Access Compliance Report

Public Rights-of-Way

(Curb Ramps)

Intersection ID: 11450	Main Street: GRANDIN_RD	Cross Street: W MARTIN LUTHER KING JR BV	Location: S
ADA ID: 38D82AE2FDD3	Ramp Type: Perp	Initial Pass/Fail: Fail	Overall Compliance: No
Severity Score: 22.5			
Codes/Mitigation Info/Possible Solution		Field Measurements/Component Compliance

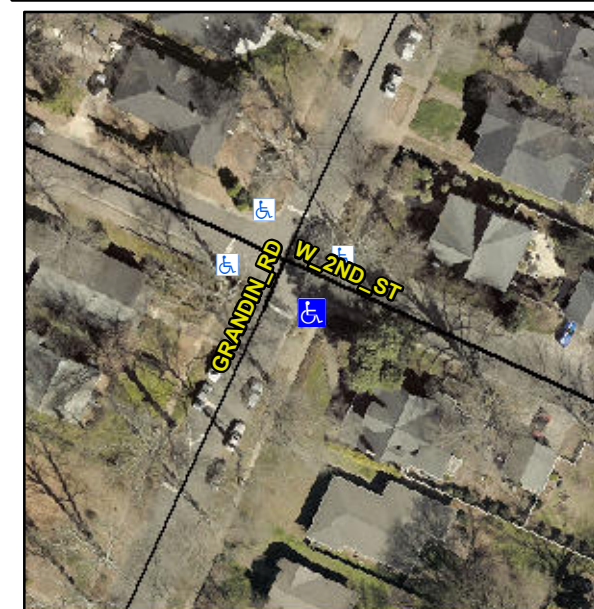
Not Found, R304.5.1, R304.2.2, R304.5.3

Compliance	Description	Data	Compliance	Description	Data
N/A	Ramp Length (in)	74.0	No	Ramp Slope (%)	8.4
No	Ramp Width (in)	47.5	No	Ramp XSlope (%)	2.4
N/A	Flare Type LT	N/A	N/A	Flare Type RT	N/A
N/A	Flare Slope LT (%)	N/A	N/A	Flare Slope RT (%)	N/A
N/A	Flare Traversable LT?	N/A	N/A	Flare Traversable RT?	N/A
N/A	Landing Length (in)	N/A	N/A	DWS Provided?	N/A
N/A	Landing Width (in)	N/A	N/A	DWS Contrast?	N/A
N/A	Landing Slope (%)	N/A	N/A	DWS Length (in)	N/A
N/A	Landing X Slope (%)	N/A	N/A	DWS Full Width?	N/A
N/A	Landing Curb? (Y/N)	N/A	N/A	DWS Offset (in)	N/A
N/A	Shared Landing?	N/A			
N/A	Gutter Ponding?	N/A	N/A	Gutter Slope (%)	N/A
N/A	Gutter Lip Ht (in)	N/A	N/A	Gutter X Slope (%)	N/A
N/A	Painted X Walk1?	No	N/A	Painted X Walk2?	N/A
	X Walk 1 Direction	To NE		X Walk 2 Direction	N/A
N/A	X Walk 1 Width (in)	N/A	N/A	X Walk 2 Width (in)	N/A
	X Walk 1 Slope (%)	2.3		X Walk 2 Slope (%)	N/A
	X Walk 1 X Slope (%)	3.8		X Walk 2 X Slope (%)	N/A

Remove & Replace Entire Ramp.
